# RENESAS TECHNICAL UPDATE

Product Category	MPU&MCU	Document No.	TN-H8*-A353A/E	Rev.	1.00
Title	Corrections of I2C Bus Interface 2 (IIC2)		Information Category	Technical Notification	
Applicable Product	See below	Lot No.	Reference Document	See below	
		All lots

We would like to inform you of the corrections on the I2C bus interface 2 (IIC2), in the H8/300H Tiny Series of the Renesas 16-bit single-chip MCU/MPU.

### Figure 15, Receive Mode Operation Timing

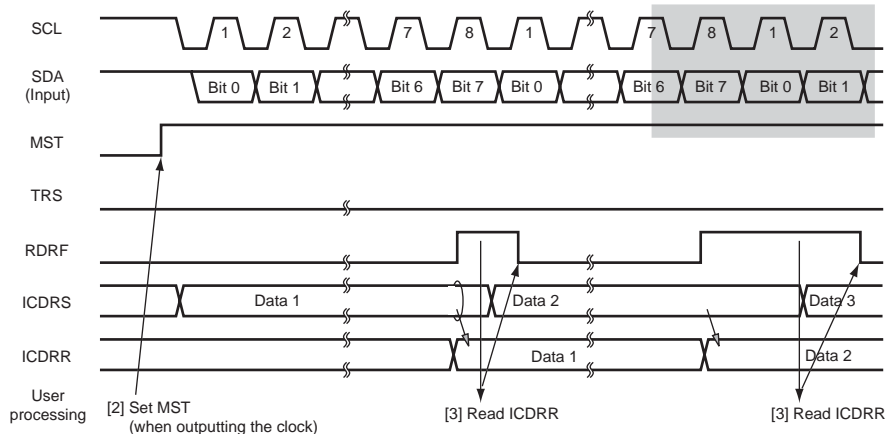
[Before change]

[After change]
